MARCH 2013

Dear customers,  
in a view to continuous reserch and improvemet of our products, we've built a new upright, designed according to needs of our customers who use our 080 system.

The code of this **new upright profile** is **080.0007**.

Kit minuteria fissaggio scatola al montante 080 Cod. 001.00521.00  
Kit small parts for fixing case to 080 upright

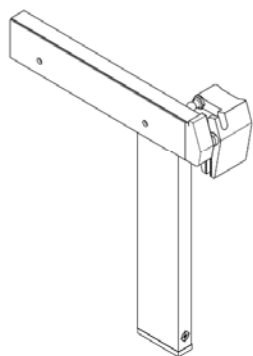
The new upright has the fixing to the ram-holder case right on the profile, with a M8 thread on a hole specially calibrated and already provided on profile's extrusion. This allows to eliminate the currently used tie rod (code 005.0233.00) and having a better looking product.

The code of the **new fixing kit of case on the upright** is **001.00521.00**.
